# 1990 Corvette: Service Bulletin: SIR Revised Code 42 Chart

**Number:** 90-229-9

**Subject:** Service Manual Update - SIR Revised Code 42 Chart

**Model Year:** 1990 Y Car

## CODE 42 INDICATOR LAMP CIRCUIT (OPEN CIRCUIT)

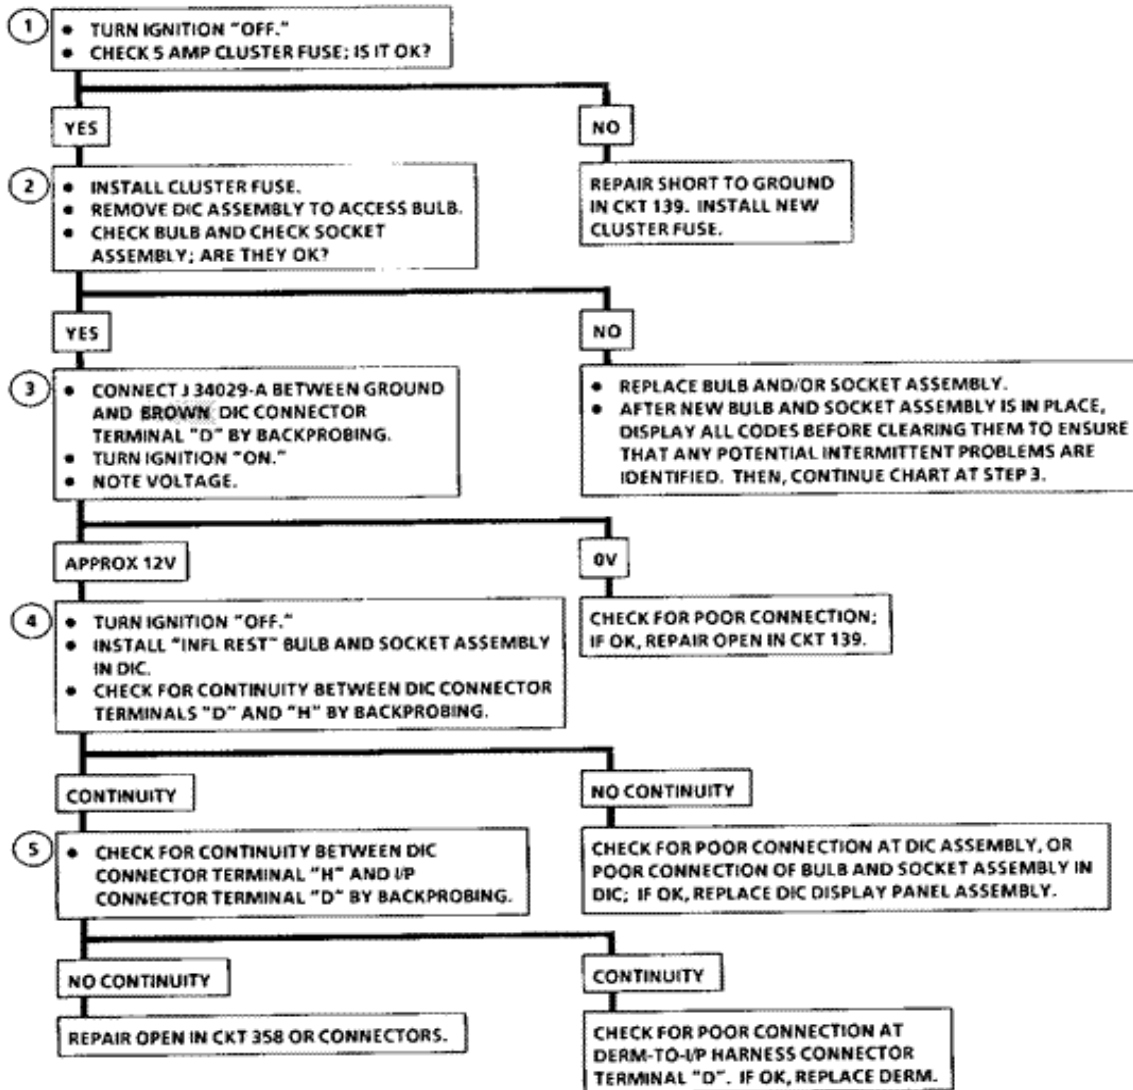
This bulletin serves to revise the Code 42 Chart on page 9J-A-43 in Section 9J-A "Supplemental Inflatable Restraint" in the 1990 "Y" Service Manual.

The blue connector referenced in the chart, step 3, should be a brown connector.

Revised art is attached.
